NOTICE OF DECISION

Meadow Brook Villas Phase 2 – Design Review – DR220-0004

DECISION AND FINDINGS

FILE NO: DR220-0004
 REQUEST: Design Review for Meadow Brook Villa’s Phase 2

SHEET C4
 PROJECT NO. 19-122.03
 SCALE 1" = 40'
 DATE 02/17/2020
 DRAWN BY [Name]
 CHECKED BY [Name]

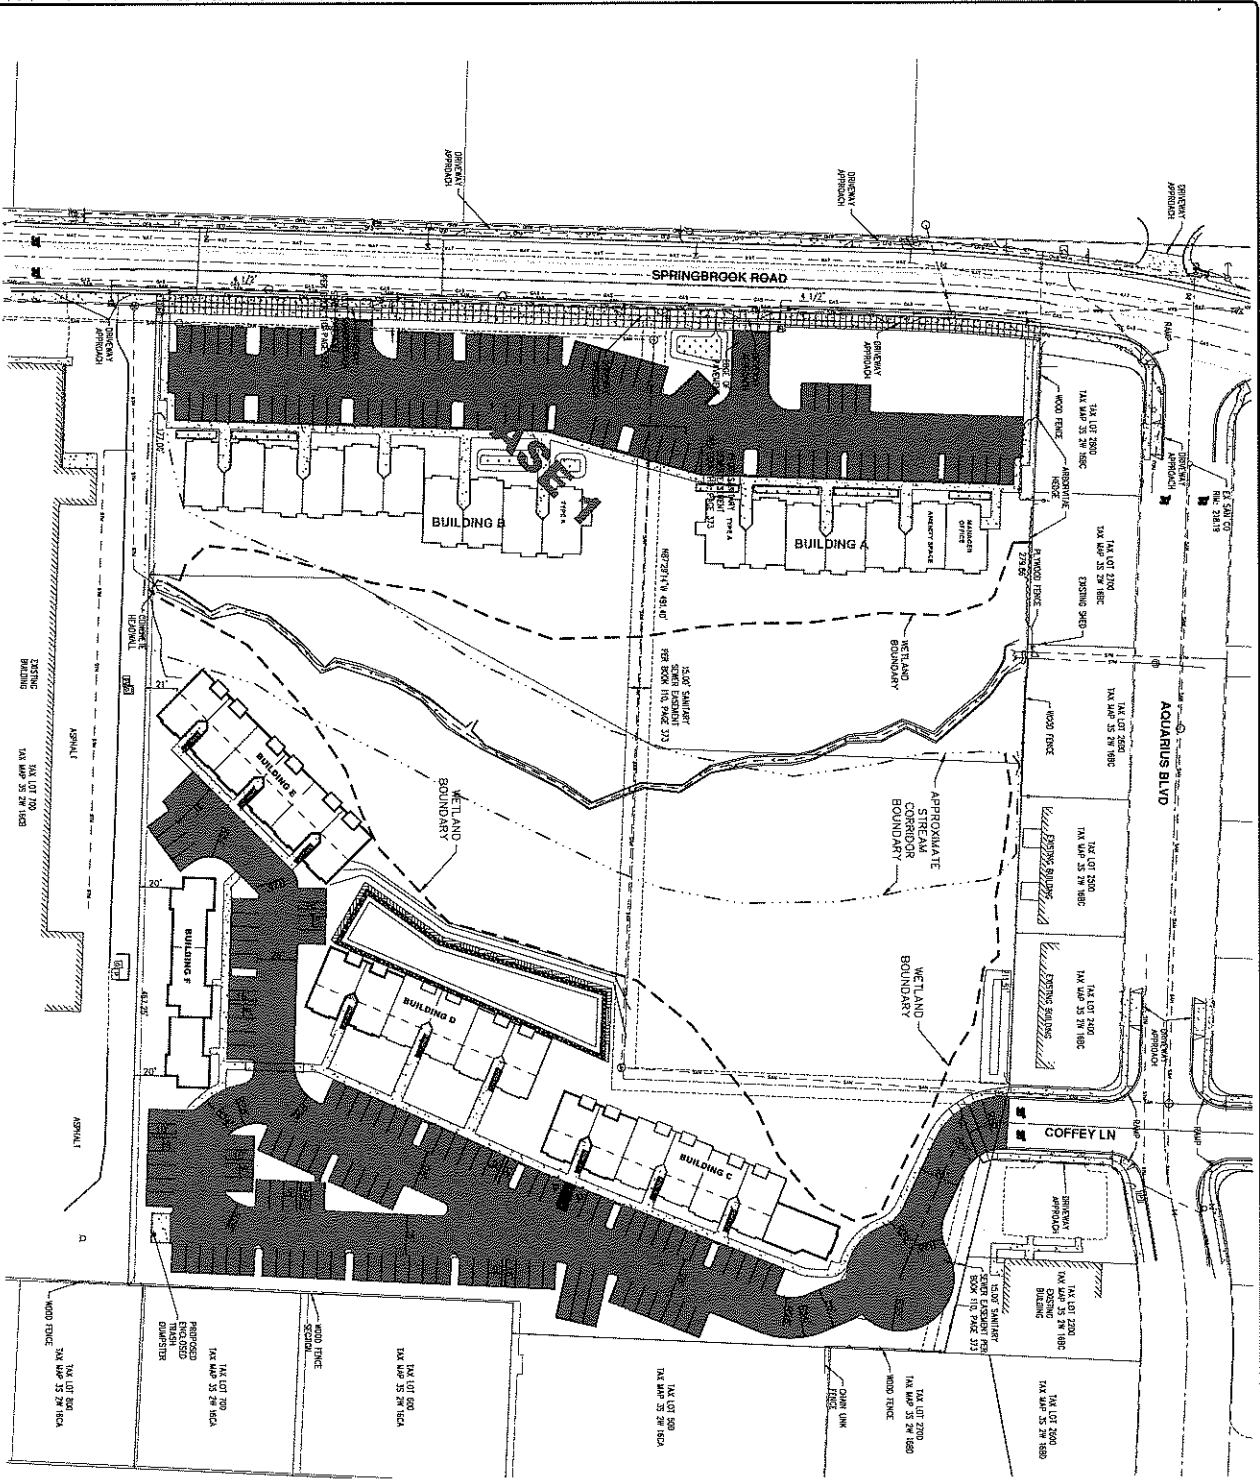
Finding: The Site Plan (Sheet C5) shows that the parking lot is designed to accommodate all vehicle maneuvering on-site with no movement required within a public street or alley. The access drive onto the unammed cul-de-sac will be 26 feet wide. The parking lot allows for a vehicle turnaround on-site provided by a looped parking configuration at the southern end as well as a turnaround area at the southwest end of the parking lot. An on-site, 5-foot-wide sidewalk accessing the main entrances to each building will connect to the proposed sidewalk on the southwest side of the future unammed cul-de-sac and connect to existing sidewalk along the existing and what is currently considered E Coffey Lane frontage. Americans with Disabilities Act (ADA) compliant ramps are proposed along the new sidewalk on the south side of the unammed cul-de-sac as well as at the terminus of the sidewalk on the northern side. The standard is met.

The Applicant's Site Plan shows 129 parking spaces with one space noted on the Site Plan by Site Note 13 to be reserved for unloading and turnaround, effectively dropping the total number of usable parking spaces to 128 spaces. The Site Plan shows five tandem parking spaces providing a total of 10 spaces in the center of the parking lot along the eastern property line. NMC 15.440.060(I) only allows tandem parking configurations as part of affordable "housing projects", as defined in NMC 15.05.030. The City of Newberg Comprehensive Plan defines "affordable housing" as dwelling unit that provides housing for a family or individual(s) with a household income less than the median household income for the Newberg area, such that a household pays no more than 30 percent of its annual income on housing (rent/mortgage, utilities, property taxes). The Applicant has not provided evidence that this project meets the definition of an affordable housing project. Therefore, a tandem parking configuration is not allowed. The removal of these tandem spaces results in less than 128 spaces and therefore, the project does not meet the minimum parking requirement. The Applicant shall remove the tandem parking spaces from the design and shall modify the project's design or request a Type I parking adjustment per NMC 15.210.020(C) to meet the minimum number of parking spaces required. The modified plans or adjustment shall be submitted to the Planning Division for review and approval prior to the issuance of building permits. With adherence to the aforementioned condition, the standard will be met.

Finding: The proposed parking lot is located on the eastern and southern sides of the property, abutting existing single-family residential homes and a commercial shopping center, respectively. The Site Plan shows (denoted by Site Note 8) wall mounted lighting proposed at each corridor entrance for each multifamily building, presumably to light building entrances as well as portions of the parking lot. Parking lot pole lighting is proposed at two locations on the site, depicted by Site Note 7 on the Site Plan. However, the Site Photometrics Plan (Sheet SP2.00) depicts five additional parking lot pole lights within landscape areas on the perimeter of the parking lot and within interior landscape islands. Light levels shown on the Photometrics Plan do not exceed the 0.5 foot-candle allowed per NMC 15.425.040; however, the Site Photometrics Plan does not appear to account for all proposed site lighting as depicted on the Site Plan. The Applicant shall provide an updated Site Photometrics Plan and wall mounted lighting cut sheets to demonstrate the standards of NMC 15.425.040 can be met and modify the Site Plan to show all proposed site lighting. The modified Site Photometrics Plan and Site Plan shall be submitted to the Planning Division for review and approval prior to the issuance of building permits. With adherence to the aforementioned condition, the standard will be met.

Finding: The Site Plan (Sheet C5) shows standard 90-degree parking spaces are proposed to be 9 feet wide by 18 feet long and include parking lot striping in addition to 26-foot-wide drive aisles and driveway. This standard is met.

PRELIMINARY STORM DRAINAGE PLAN

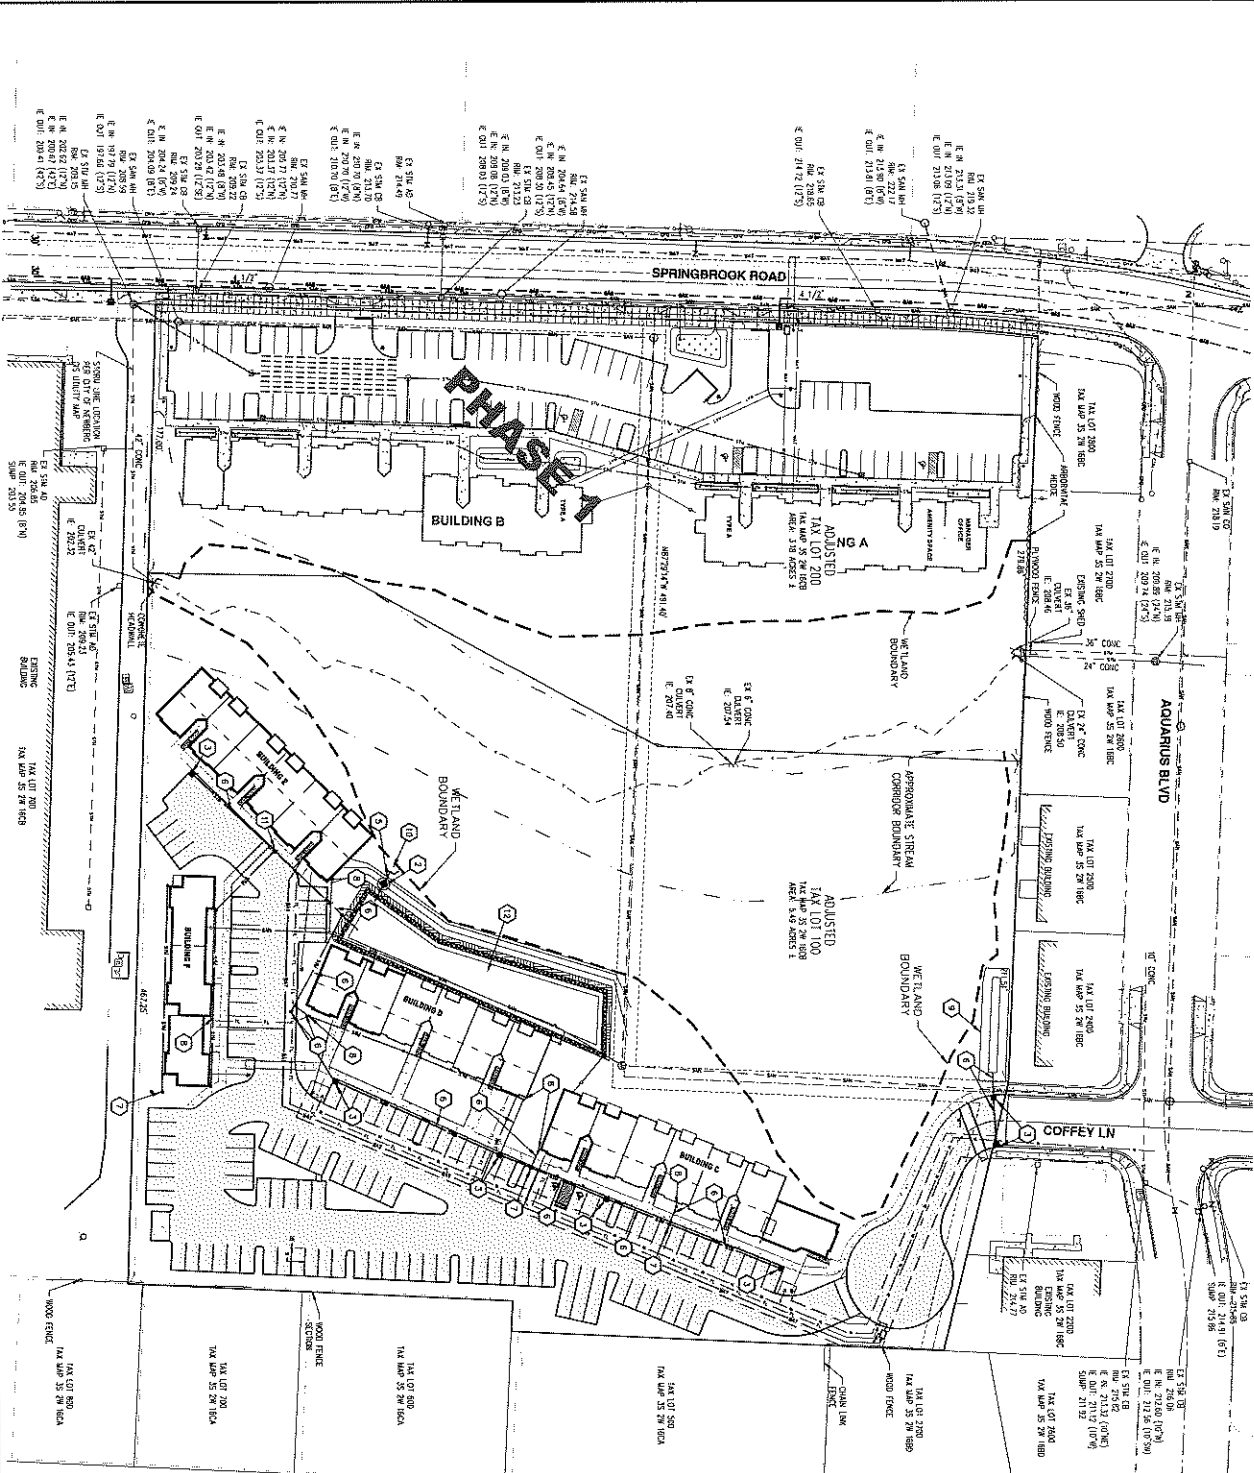
4. On design plans sheet C7, Note 10 is missing. Is the applicant proposing to discharge stormwater into the existing creek/drainage? If so, DEQ permitting (JPA) for a stormwater outfall is required if it's occurring inside of the Stream Corridor boundary.
5. On the design plans sheet C7, Note 9 references a public rain garden but no call out can be found on the design plans. Is the applicant proposing a public rain garden?

BASEMENT AND 1ST
 FLOOR PLANS

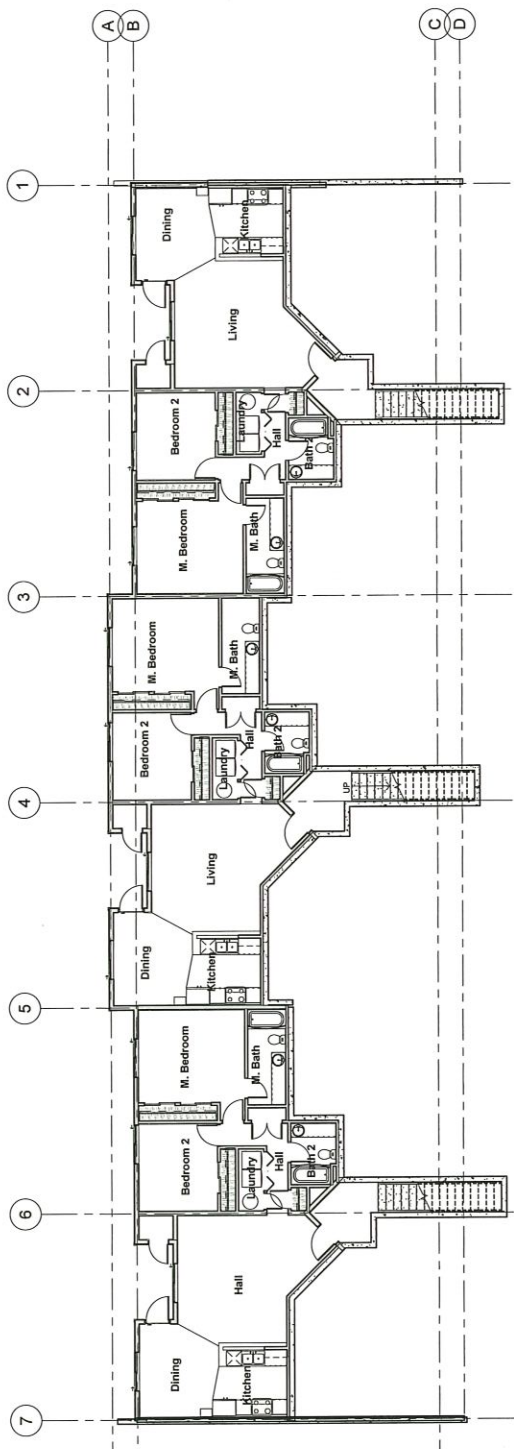
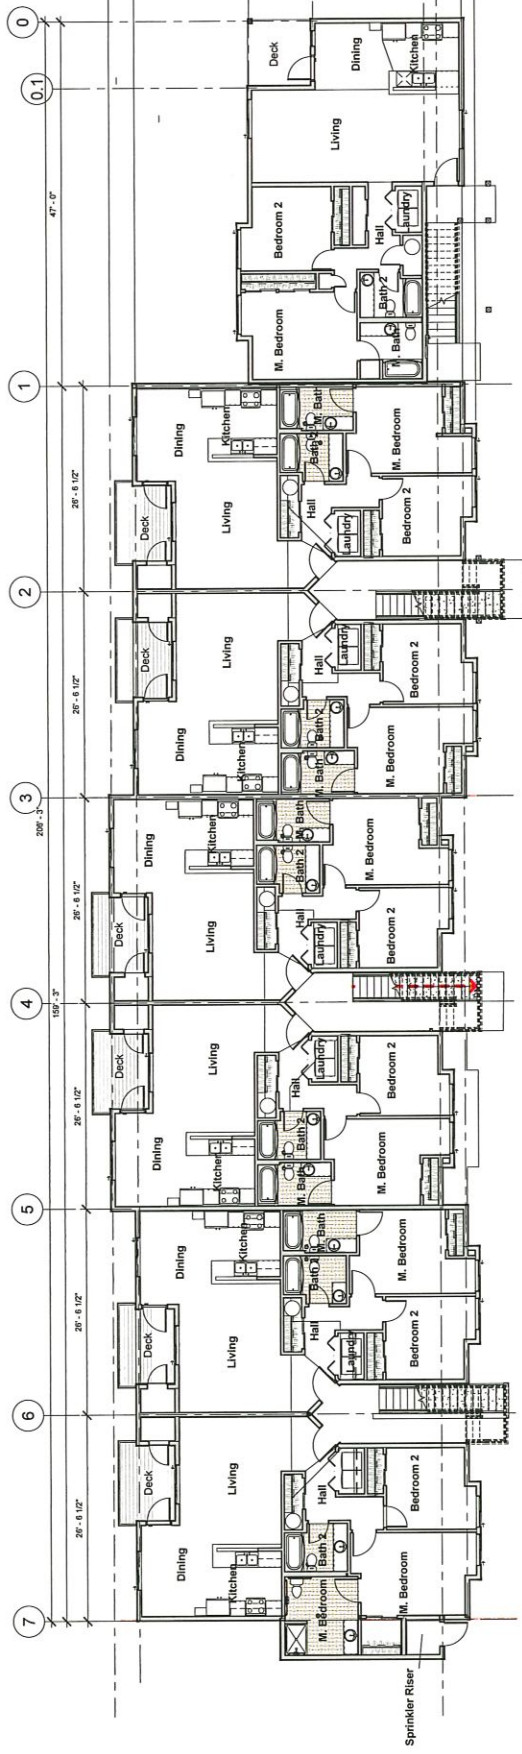
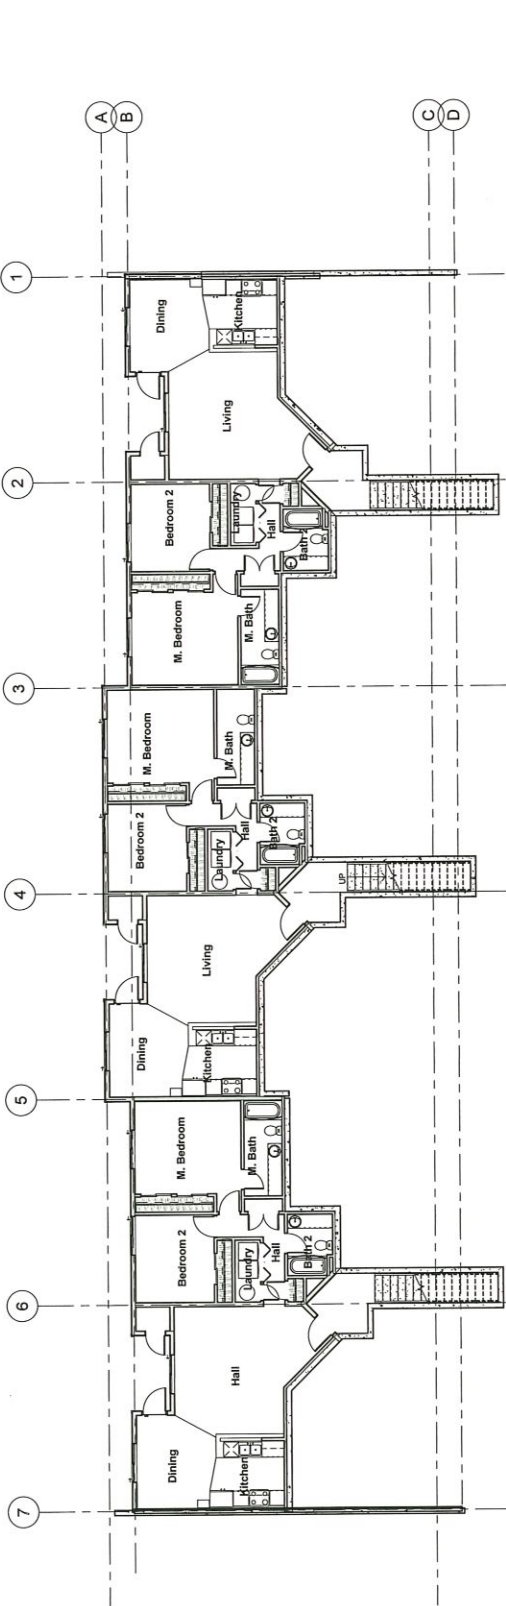
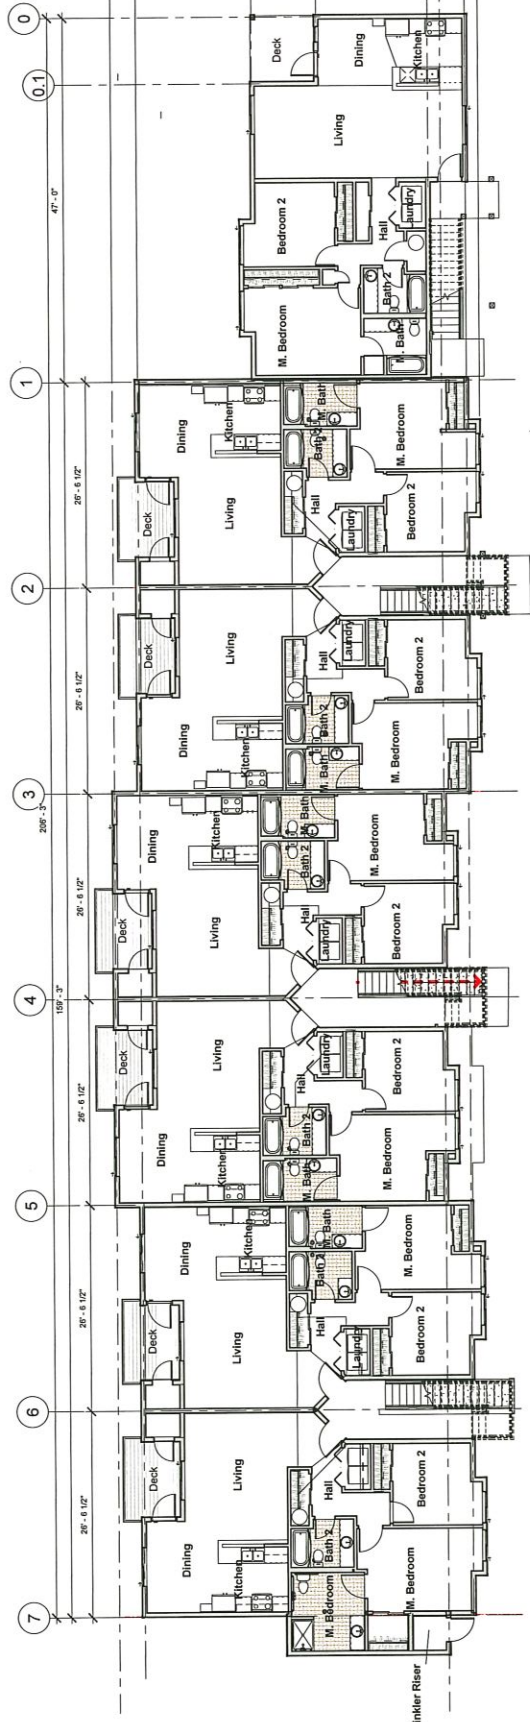
Finding: The Applicant's Architectural plans show buildings exceed the 30 foot height limit. Therefore, compliance with the Alternative Building Height standard is required and discussed below.

Finding: The Architectural Plans do not adequately depict how the Alternative Building Height standard is met.

Buildings C, D, and E appear to comply with the Alternative Building Height standard. However, the Architectural Site Plans and Site Plan are not consistent in how they depict building locations.

Finding: The Architectural Plans show that each ground-floor apartment unit will have individual outdoor spaces. The Applicant's narrative indicates each space is 69 square feet, however, ground floor patios on Building F and Building E appear smaller than the 48 square-foot outdoor private space minimum. It is unclear if patio paving will extend beyond the building face. Prior to building permit issuance, the Applicant shall include a total area for ground floor patios on floor plans for Buildings E and F demonstrating compliance with the 48-square-foot minimum standard. This criterion will be met with the adherence to the aforementioned conditions of approval.
